PD-25-09 (Quasi-Judicial)

(Adoption Hearing BCC Land Use Meeting 09-09-2025)

KL Westport Expansion LLC

Proposed Changes

Natural Buffer Requirement

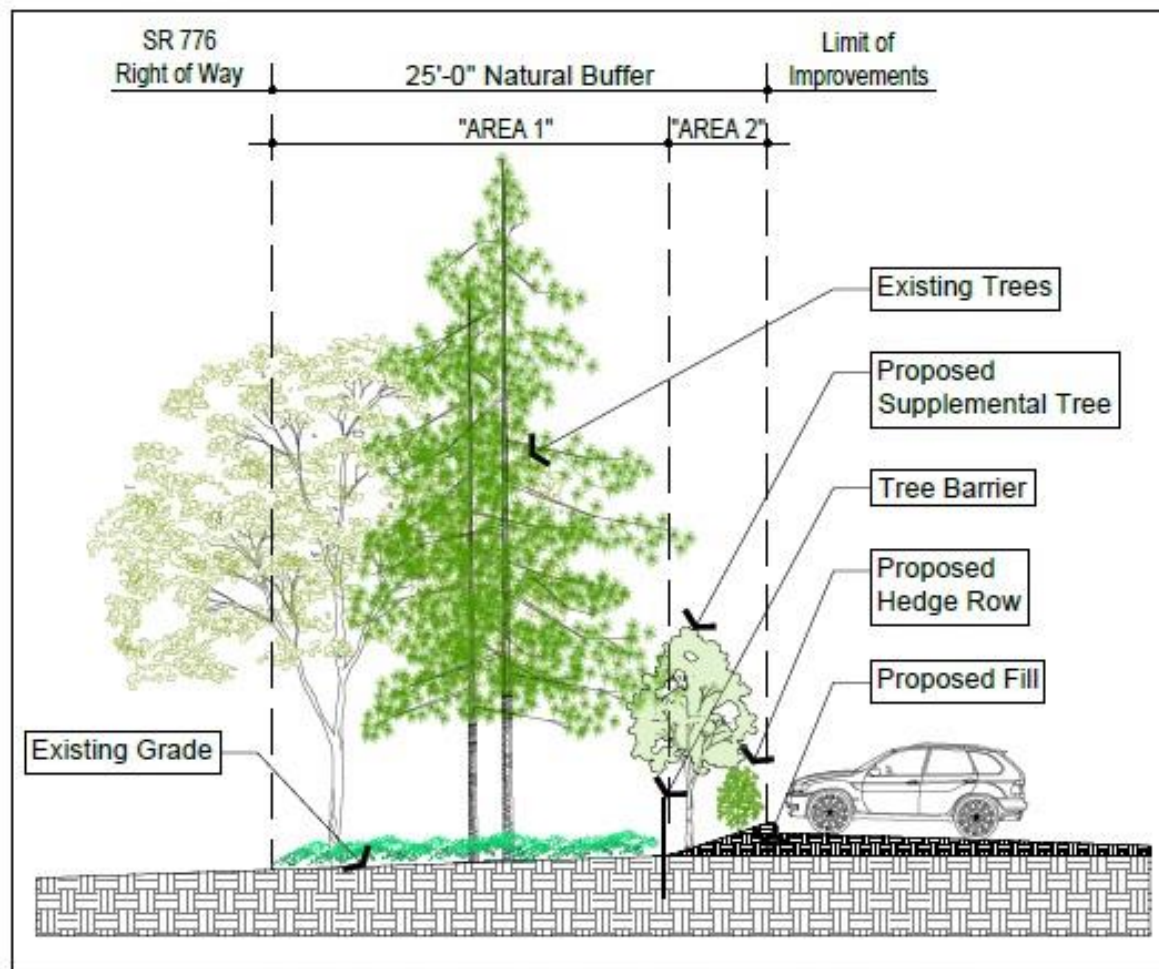
- The adopted PD condition “m” requires that: All trees less than eight inches Diameter at Breast Height (DBH) and palms less than 12 inches DBH may be removed from Area 1 (20-foot) of natural buffer.

**REMOVALS &
ADD'L SAVES**

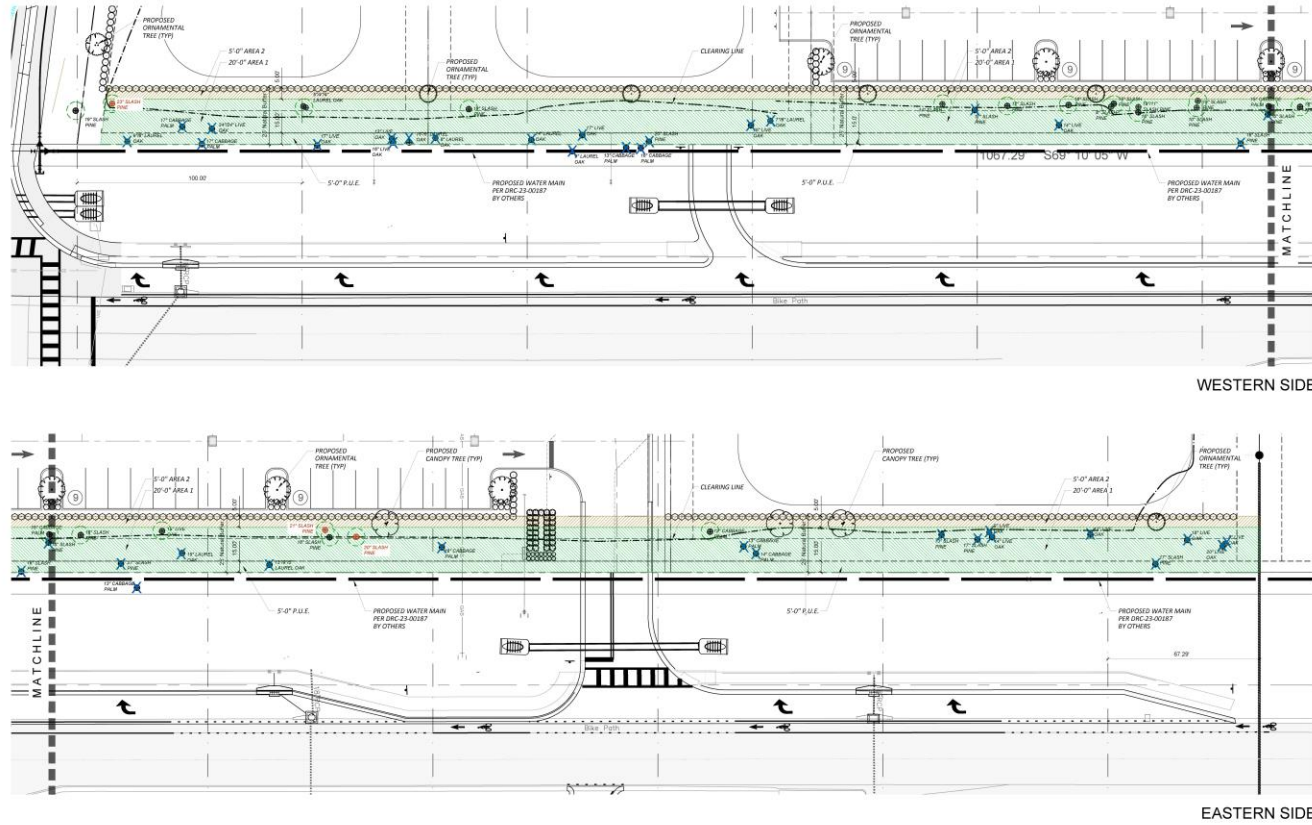
- For trees equal or greater than eight inches DBH and palms equal or greater than 12 inches DBH, which have been removed from Area 1 as shown on Figure 1 due to installation of utilities, the Developer is required to replace removed trees located outside any County approved Public Utility Easement (PUE) with like size trees.

- If the trees removed cannot be replaced in kind and size, multiple native trees equaling the total tree points removed will be allowed.
- The Developer may replace removed pine trees with approved native hardwood trees per the County's list of approved tree species with prior written approval from the Community Development Department.

- All replacement trees shall be planted in the same general locations as they were removed outside of the easement areas within the Natural Buffer Area 1 but outside any PUE.
